STREET AND DRAINAGE CONSTRUCTION PLANS

Reviewed by City of Boerne Development Services:

5th Review

CORLEY FARMS OFFSITE
VALLERIE LANE IMPROVEMENTS
STREET & DRAINAGE
CONSTRUCTION PLANS

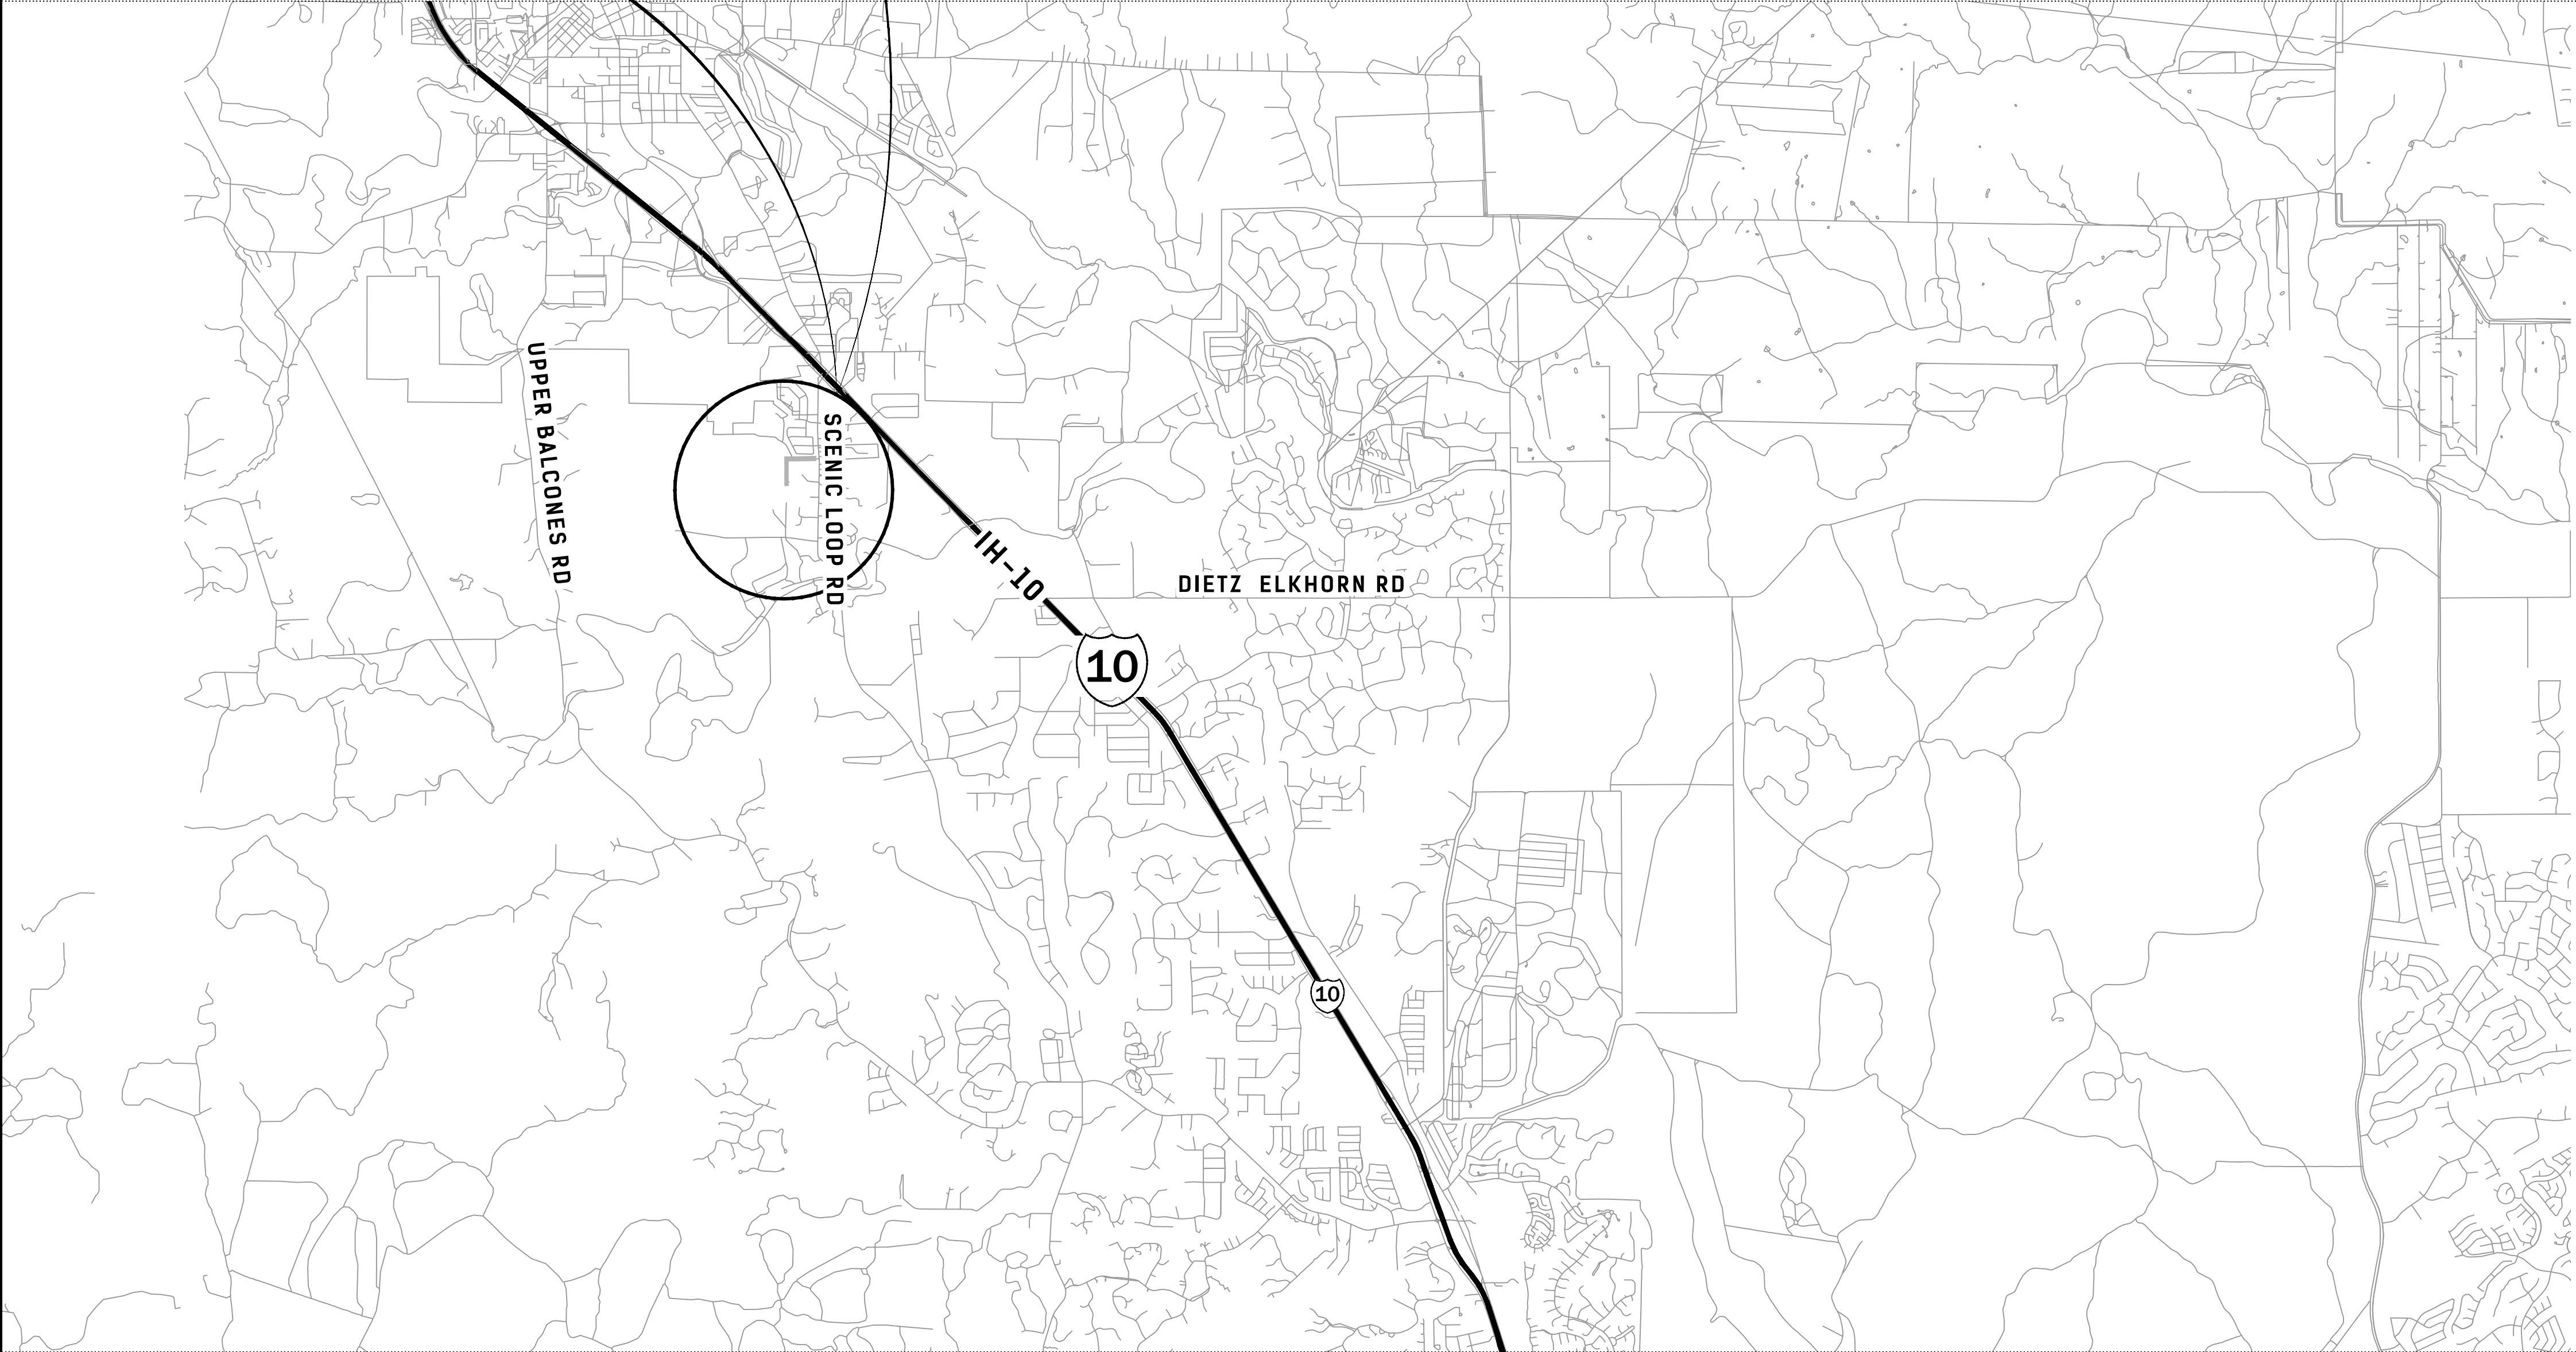
-offsite easements must be obtained prior to application of the construction release permit
-Obtain county approval prior to application of the construction release permit
-DA amendments/MOU must be finalized prior to approval of construction release permit
